Access Compliance Report

Public Rights-of-Way

(Curb Ramps)

Intersection ID: 24503	Main Street: BRUFF_CT	Cross Street: SAINTFIELD_PL	Location: E
ADA ID: B2E62CCE304A	Ramp Type: BlendTrans1	Initial Pass/Fail: Fail	Overall Compliance: No
		Severity Score: 8.75

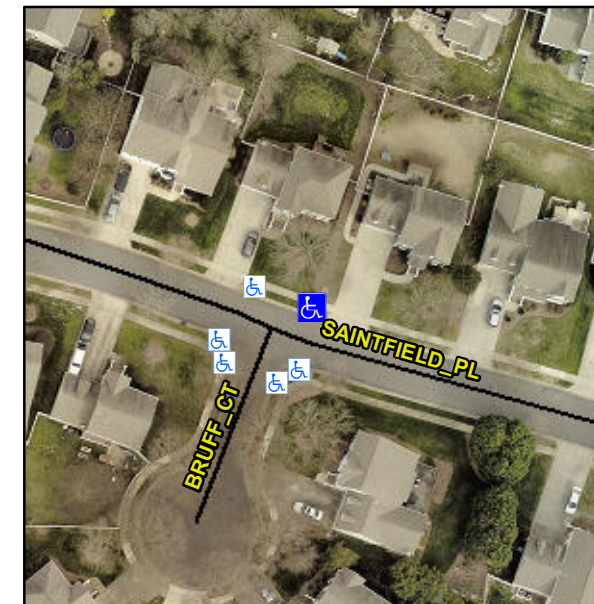
PROW/ADA:

Not Found, R304.5.1

Possible Solutions:

Remove & Replace Curb Ramp With Two New Directional Ramps or Equivalent.
